SUNDRY NOTICES AND REPORTS ON WELLS
Do not use this form for proposals to drill or to re-enter an abandoned well. Use Form 3160-3 (APD) for such proposals.

1. Type of Well ☒ Oil Well ☐ Gas Well ☐ Other		7. If Unit of CA/Agreement, Name and/or No. NMNM-135216A
2. Name of Operator Enduring Resources IV, LLC		8. Well Name and No. W LYBROOK UNIT #756H
3a. Address 200 Energy Court Farmington NM 87401	3b. Phone No. (include area code) 505-636-9743	9. API Well No. 30-045-35819
4. Location of Well (Footage, Sec., T., R., M., or Survey Description) SHL: 2618' FSL & 2088' FEL Sec 23 T23N R9W BHL: 330' FNL & 619' FWL Sec 15 T23N R9W		10. Field and Pool or Exploratory Area Lybrook Mancos W
		11. Country or Parish, State San Juan, NM

Enduring Resources requests a change to the drilling program per attached updated:

WELL LOCATION AND ACREAGE DEDICATION PLAT

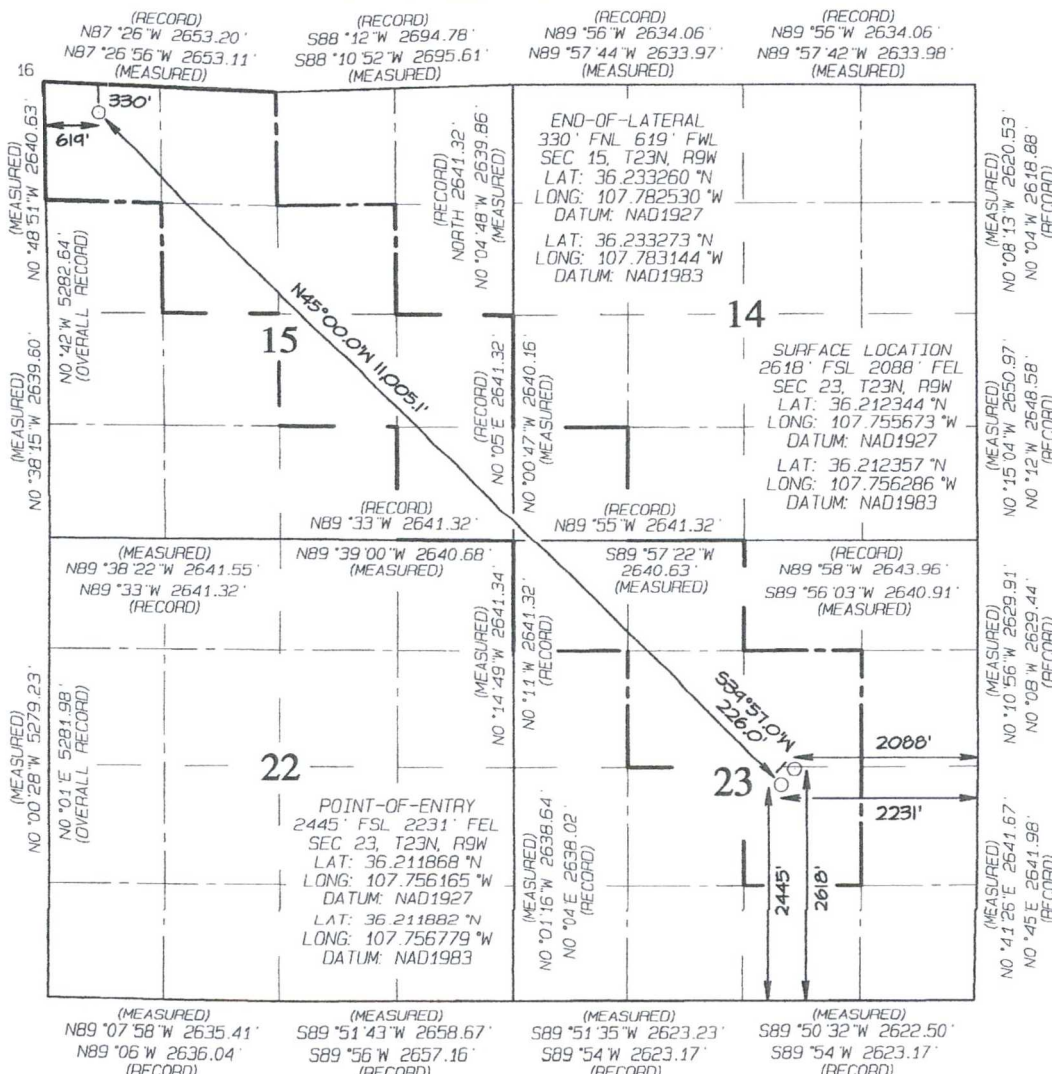
C102
OPS plan
Directional plan
Wellbore

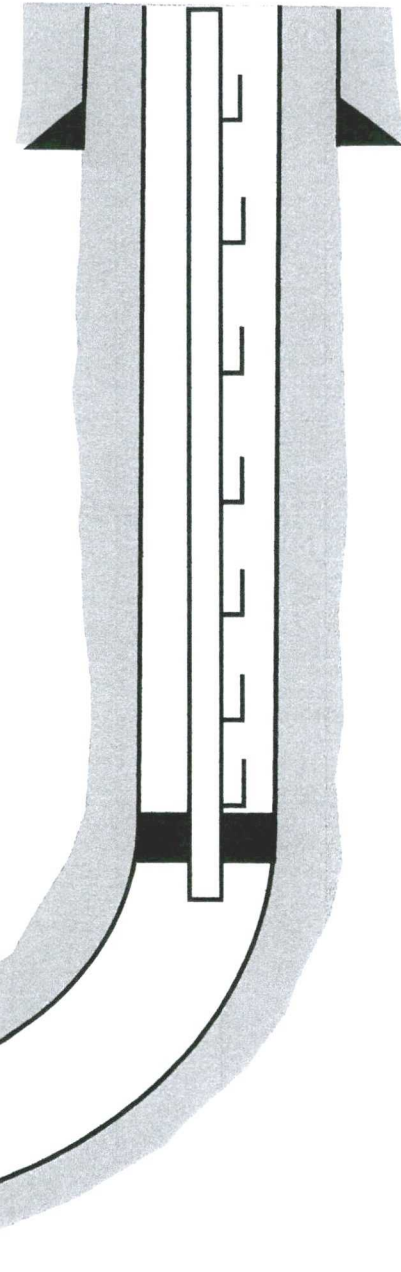
NOTE: WPX previously drilled cased, and cemented the surface hole.
